Climate Change Implications of the proposed Hunterston Power Station.
A summary report of the carbon and climate change implications of the proposed
Hunterston coal-fired power station.

Based on research conducted by Element Energy.

October 2011.

Figure 1

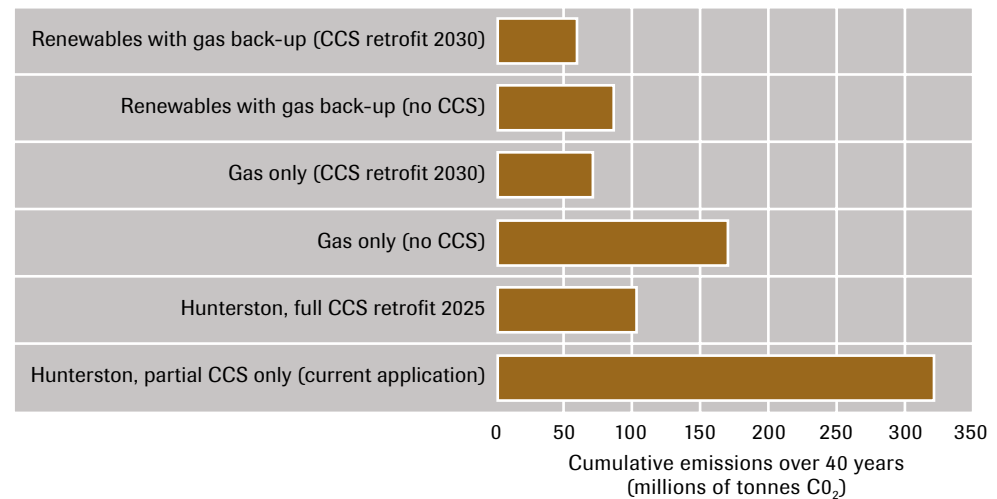
Element Energy contrast the Hunterston proposal with such a scenario, revealing the true comparative emissions (see Figure 1). They also consider the possibility that retrofit may not ever be commercially viable. APL has claimed its proposal would be preferable to gas-fired generation, but that assumes – misleadingly – that the alternative would be to generate the same amount of electricity using *only* gas (not a mix of renewables and gas), *and* that the Hunterston plant would be retrofitted by 2025, *and* that gas power would never be retrofitted with CCS¹⁵.

Over a forty year lifespan, with only partial CCS, Hunterston would emit almost four times more CO₂ than the alternative renewables/gas portfolio. Even if fully retrofitted in 2025, Hunterston would still generate around 20% more CO₂ than the renewables/gas portfolio over 40 years (see Figure 1). For the Hunterston proposal to generate lower cumulative emissions in comparison to the renewables/gas portfolio (without gas CCS retrofit) it would need to retrofit implausibly early, by 2022 (within five years of initial commissioning)¹⁶.
